Sundry Print Report

Well Name: MORRIS A

Procedure Description: Hilcorp Energy Company wishes to REVISE the perforations for the Fruitland Coal recompletion. Please see the attached revised procedure.

HILCORP ENERGY COMPANY
MORRIS A #13A
FRC RECOMPLETE SUNDRY
API 3004526586

MORRIS A #13A - PROPOSED WELLBORE SCHEMATIC

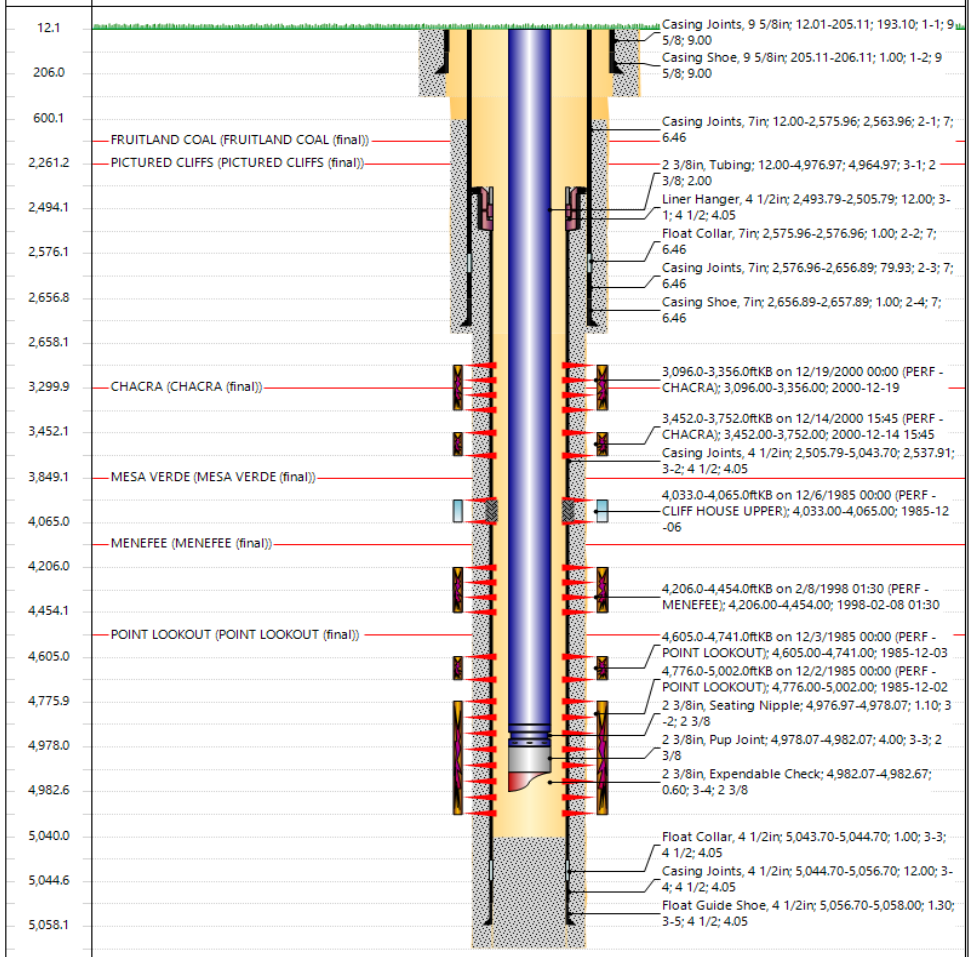
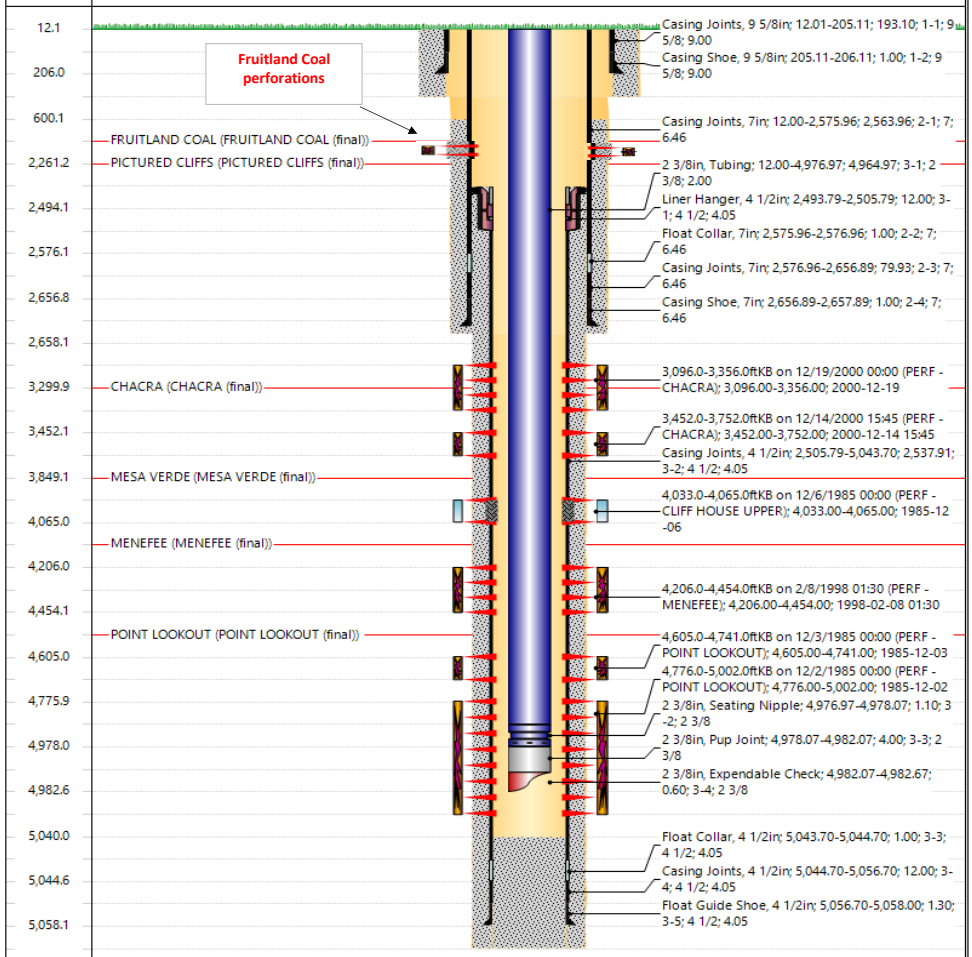
6. **If frac'ing down casing:** pressure test casing to frac pressure.
7. RU WL. Perforate the **Fruitland Coal.** Top perforation @ **2,040'**, bottom perforation @ **2,261'**.

JOB PROCEDURES
1. MIRU workover rig and associated equipment; NU and test BOP.
2. TOOH with tubing.
3. Set a plug within 50' of the top **Chacra** perforation **(3,096')** for zonal isolation.

15. TIH and land production tubing. Flowback the well. Return well to production as **Mesaverde/Chacra/Fruitland Coal Producer.**
